TECHNICAL SERVICE BULLETIN

TSB-OT-0019 REV2

Subject: Revision - 5-Ton Rooftops DFG/DFC Missing Valve Cores in Pressure Switches

Image 1
Valve Core Omitted

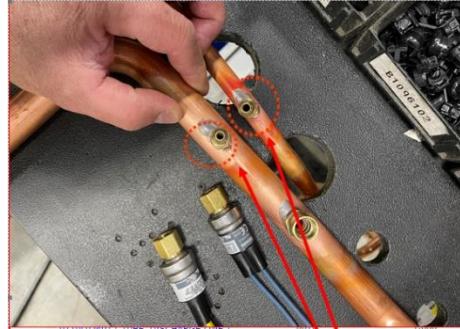
It has come to our attention that the new 1- and 3-phase, 5-ton gas/electric and air conditioner rooftop units (RTU), models DFG and DFC, are missing the valve cores in the low-pressure and high-pressure switch assemblies (see Image 1 below).

All 5-ton (DFG/C060*) RTUs, with serial numbers up to 2202235971, should not be sold or installed until the rework is completed. It is strongly recommended that all distributors promptly contact and inform any customers that have purchased and/or installed any of these units of the required rework by way of this bulletin.

Image 2
Valve Core Installation

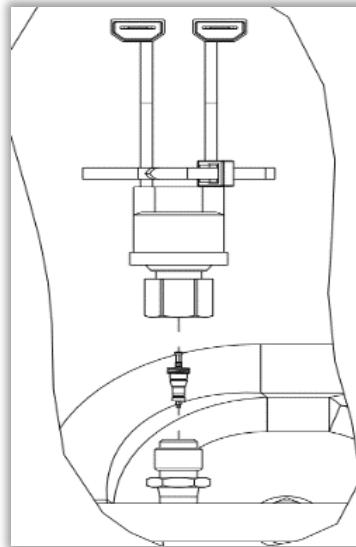
3. Once the refrigerant has been recovered, remove the low-pressure and high-pressure switches.
4. Determine if the valve core fits into the existing fitting as shown in Image 2 below.

1. Install the valve core (refrigerant rated) Daikin part number B1787000 supplied in kit CPSKT01 in each fitting, torquing to 4 +/- 1-inch lbs. See Image 2 below.

Image 3
Tee Adaptor

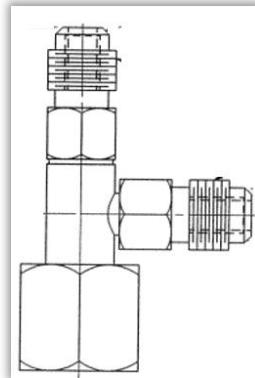
1. If the valve core does not properly fit into the existing fitting, install the tee adaptor supplied in kit CPSKT01 and follow the steps below. See Image 3 below.

2. Add thread sealer, provided in kit CPSKT01, to the threads of the fitting.
3. Install the tee torquing to 96 +/- 5-inch lbs. Use a back-up wrench to hold the fitting to prevent twisting and leaks at the braze joint.
4. Install the low-pressure switch on the suction line and high-pressure on the discharge line torquing each switch to 96 +/- 5-inch lbs. Use a back-up wrench to hold the fitting to prevent twisting and leaks at the braze joint.
5. Install the valve cap, supplied in kit CPSKT01, on the unused side of the tee.
6. Place the warning label around the suction and discharge lines next to the tee.
7. Evacuate the unit to 500 micron and hold.
